## **Planning and Referral Agency Comment Letters – presented in reverse chronological order**

Re: Comments for Case AN-265-22, Z-984--22, V-94-22

TO: Anita Riley, Planner  
FROM: Lee Alverson, Development Review Engineer  
DATE: June 8, 2022  
SUBJECT: AN-265-22 Z-984-22 V-94-22; 7001 Colorado Blvd, 2<sup>nd</sup> Comments

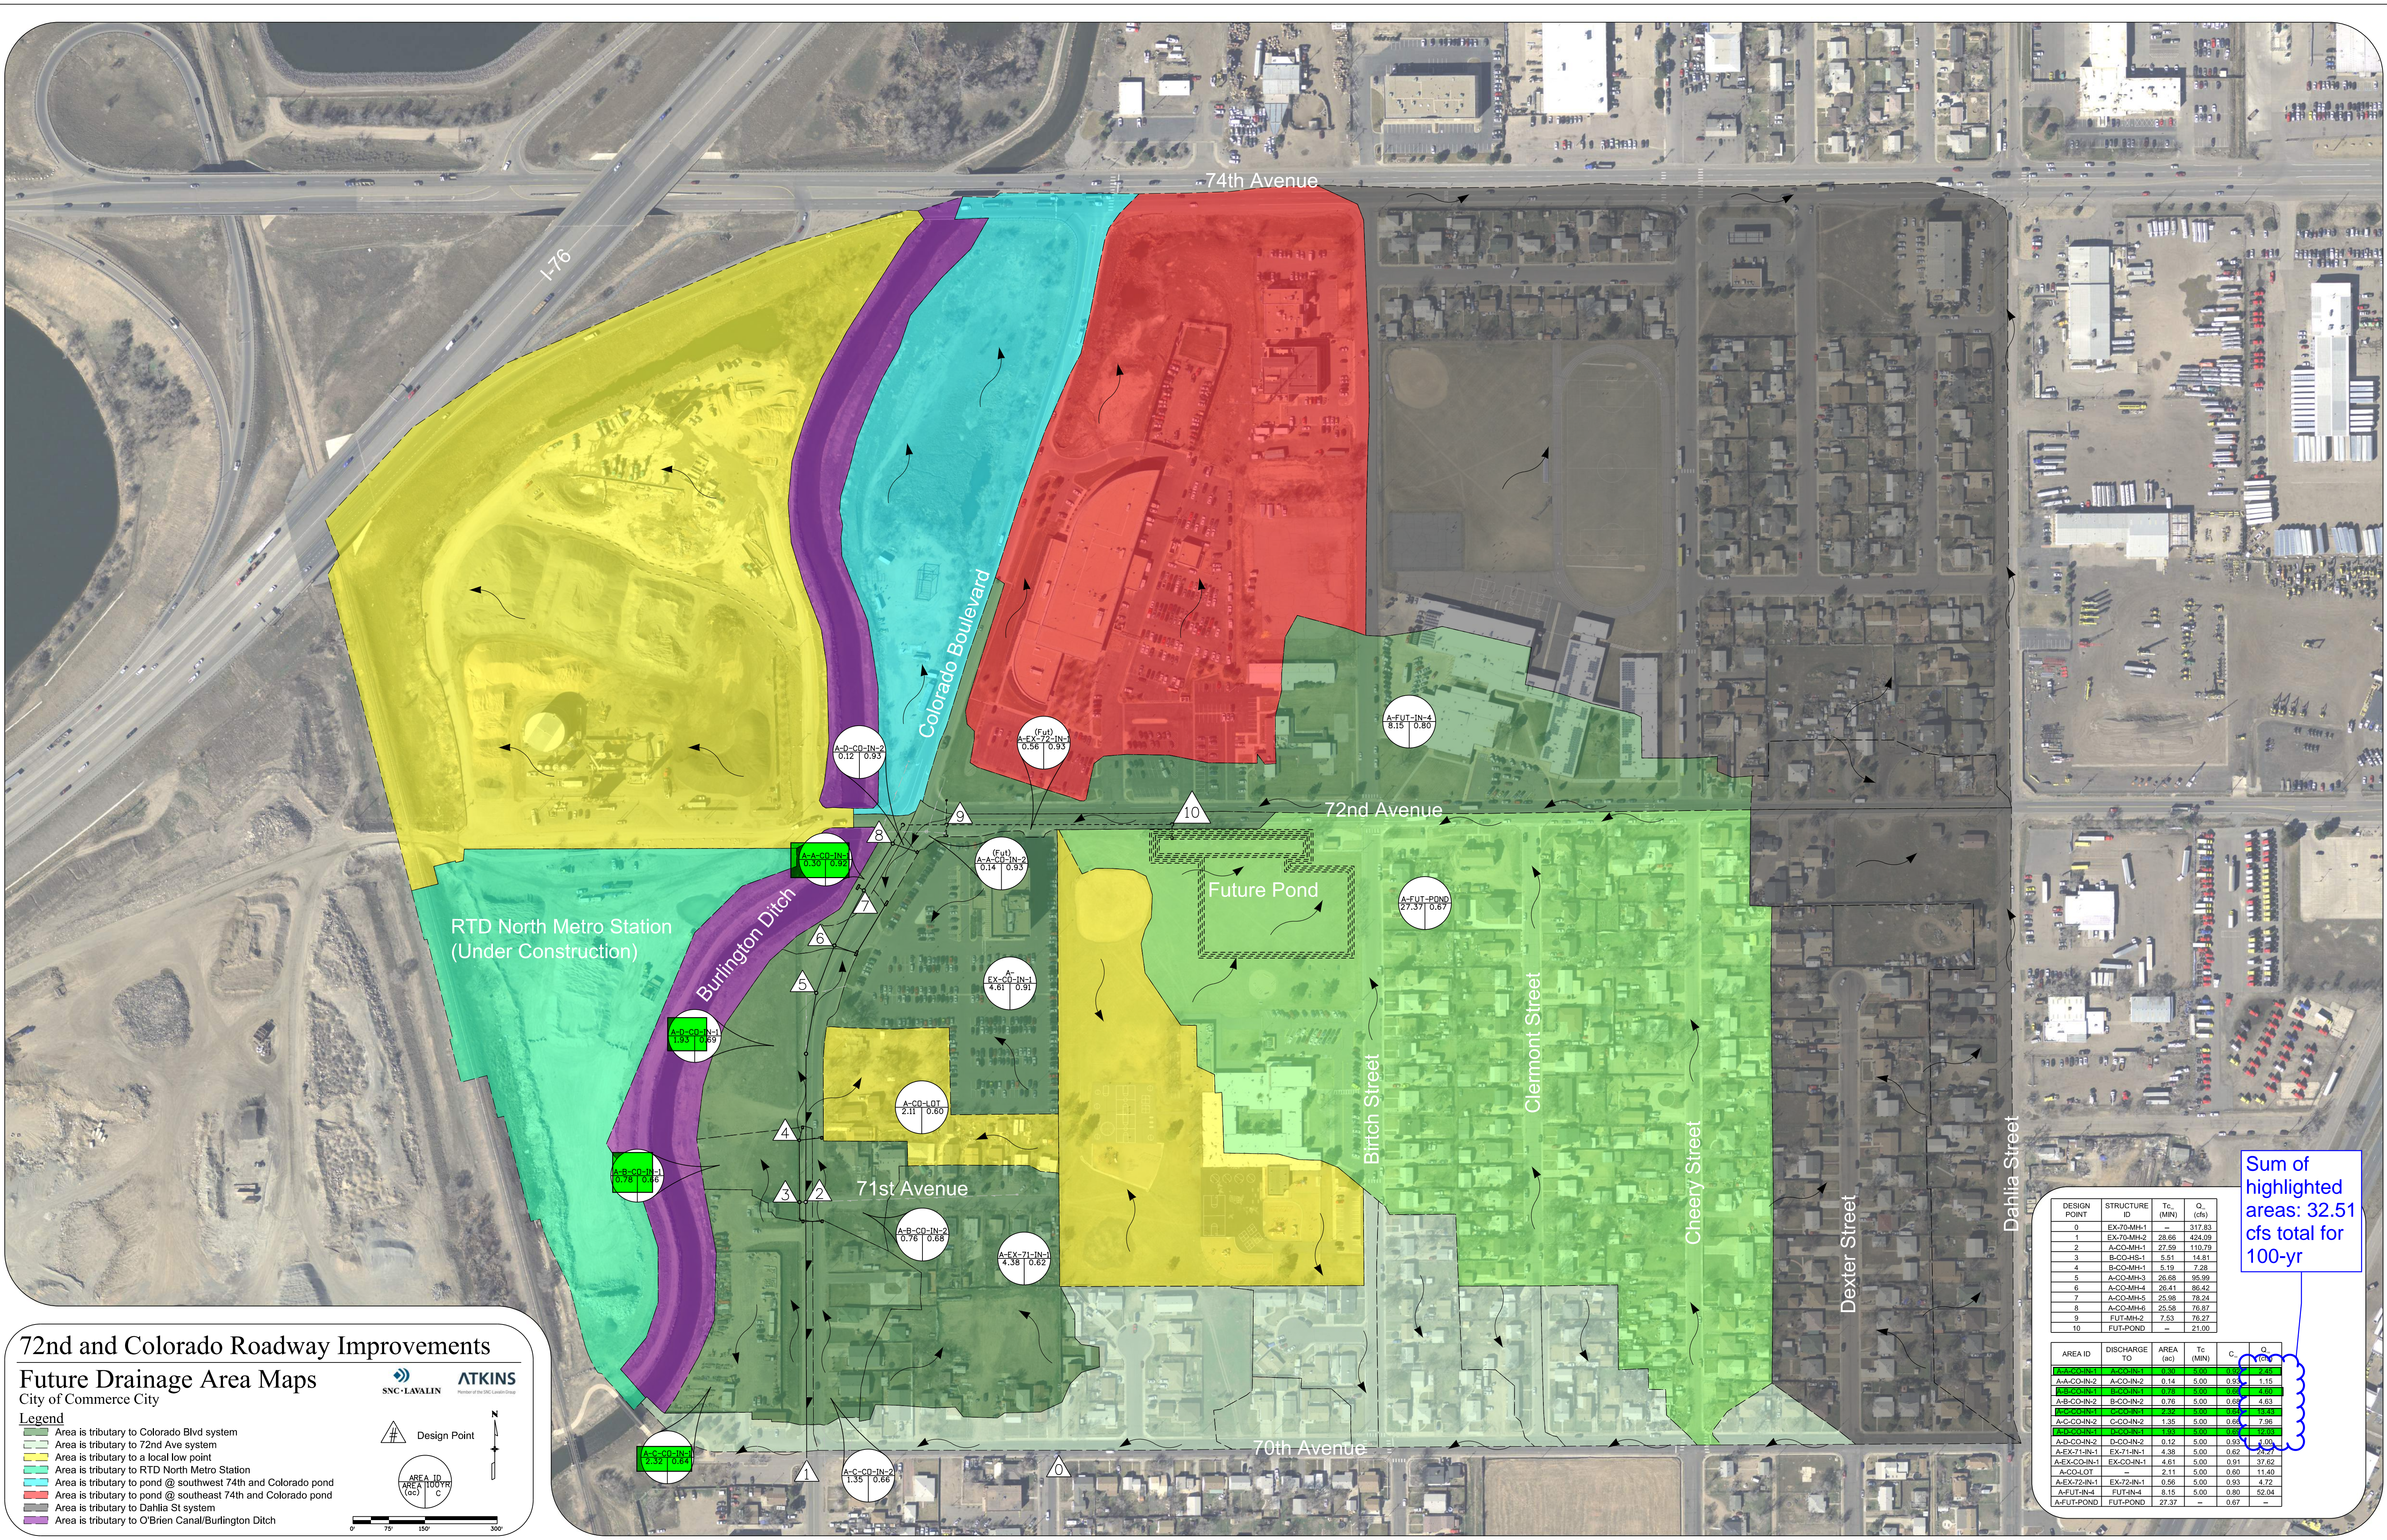
Incoming flow?

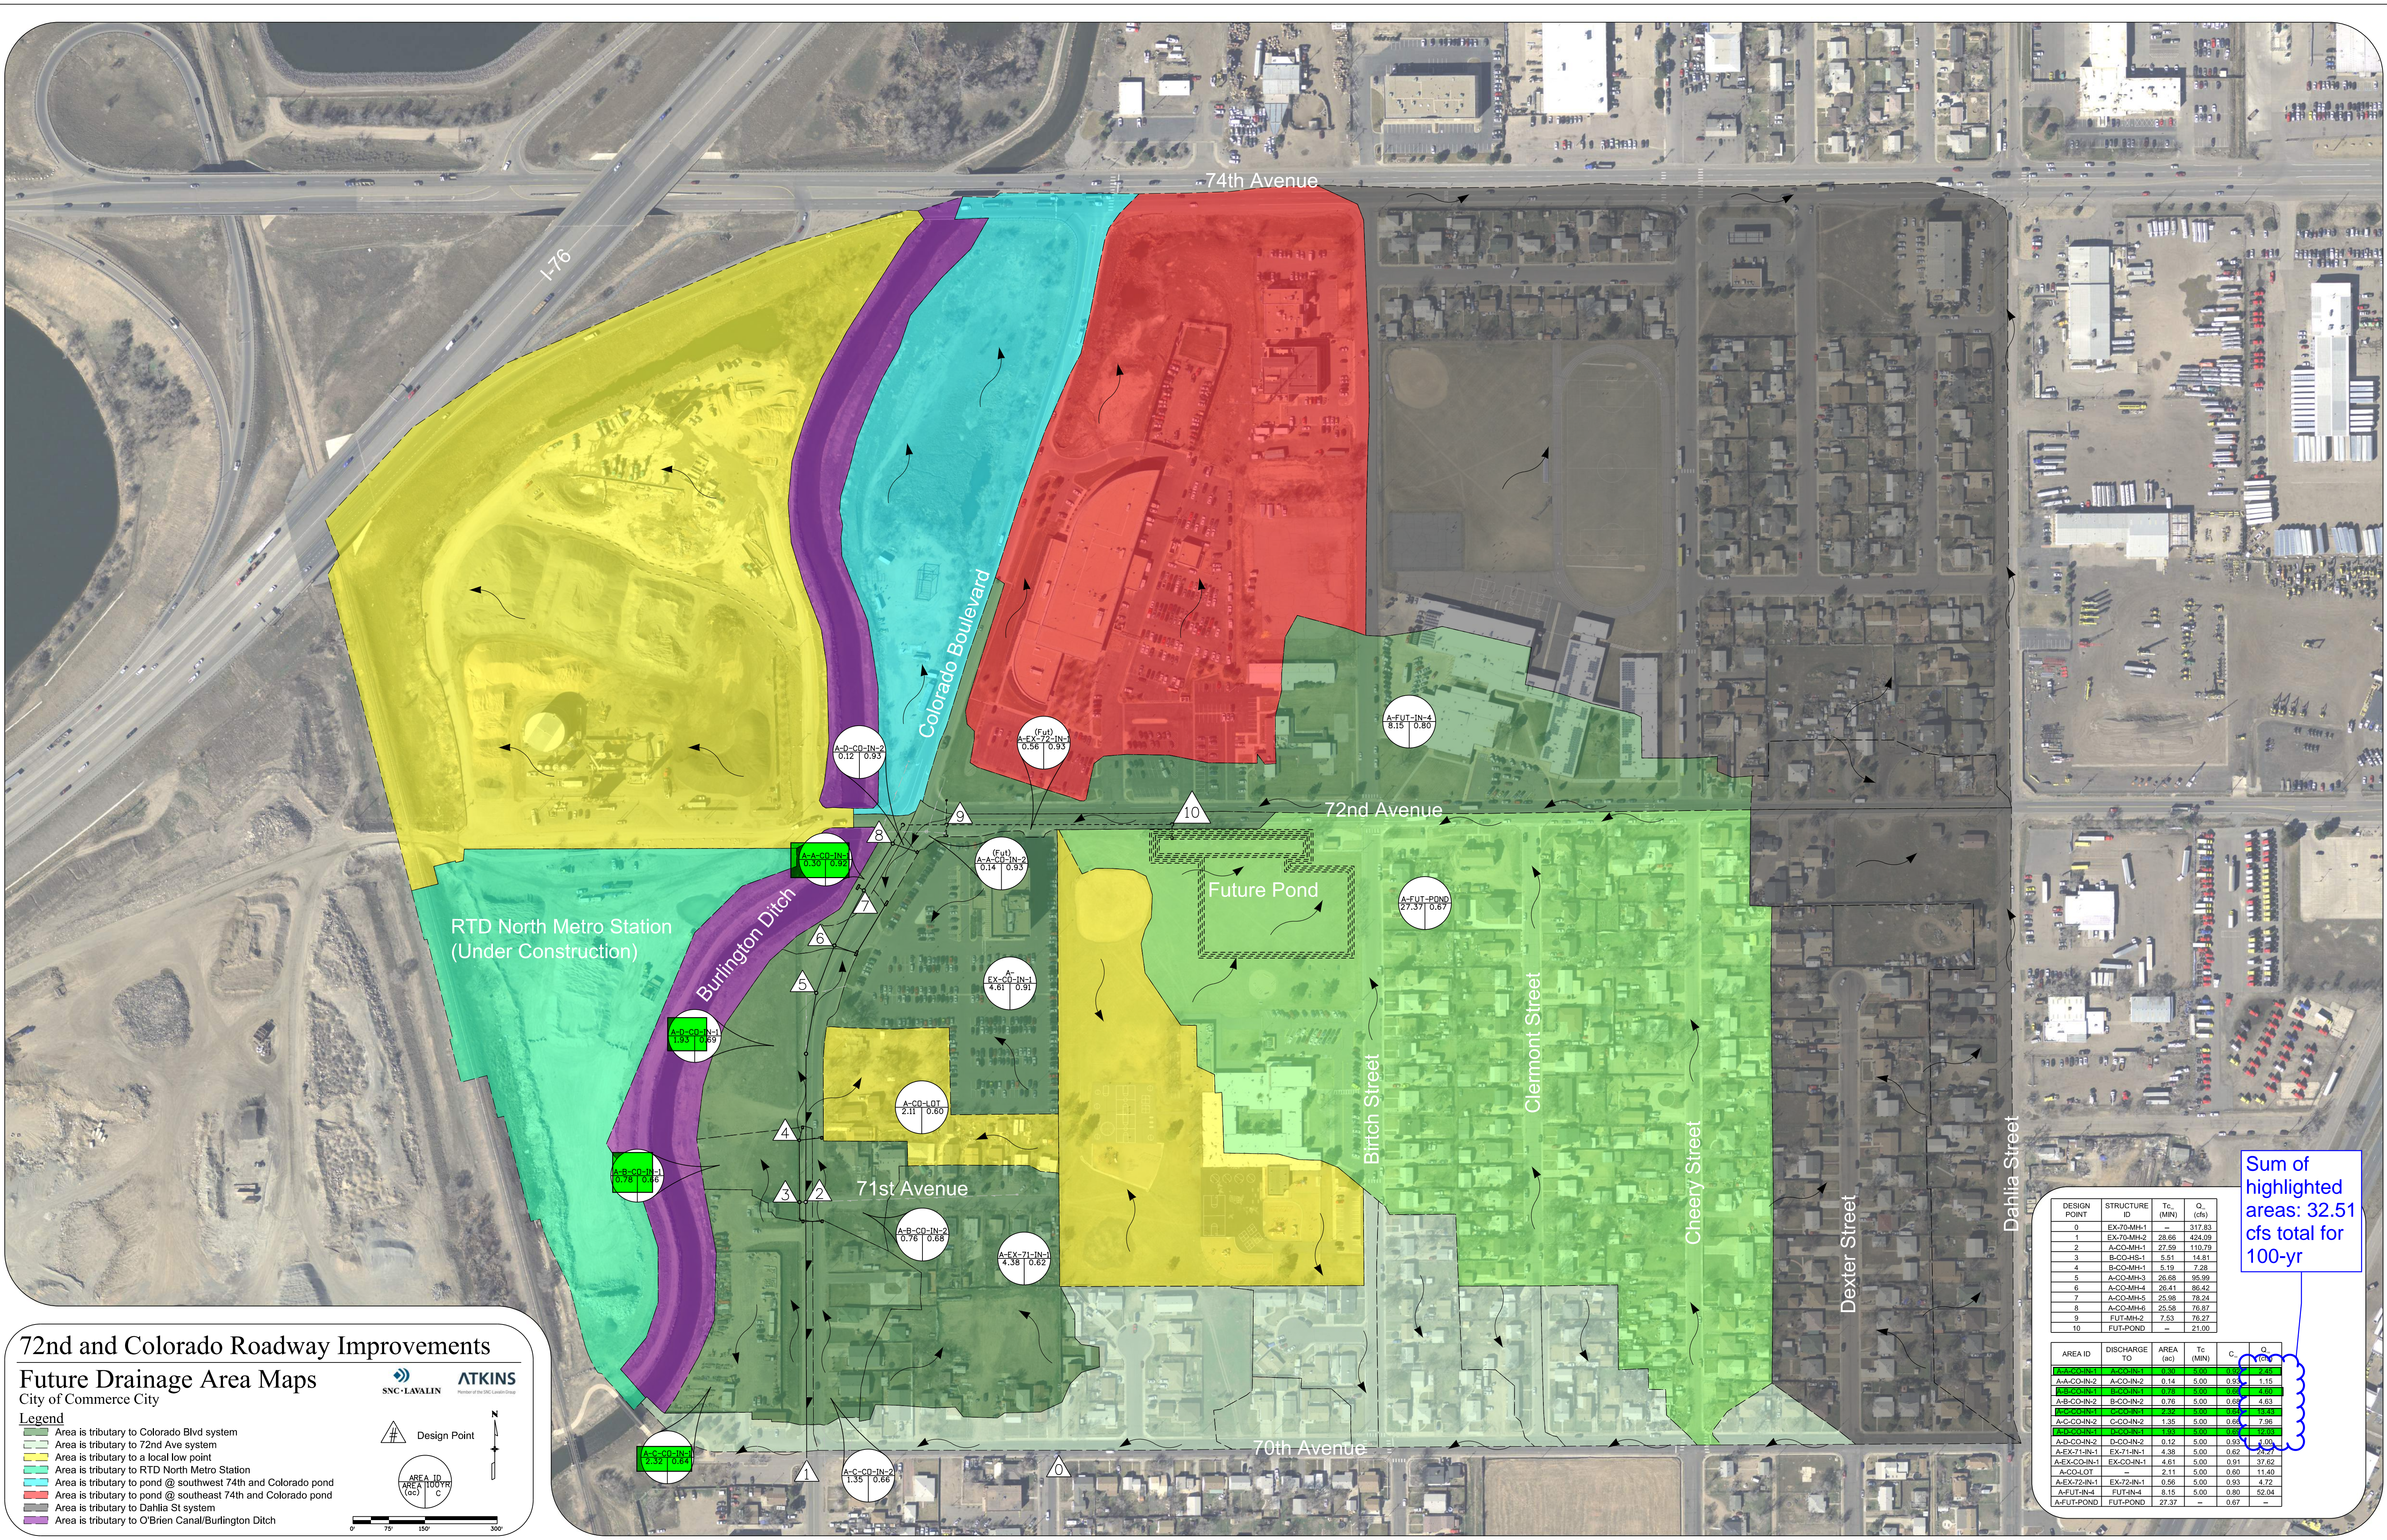
Incoming flow?
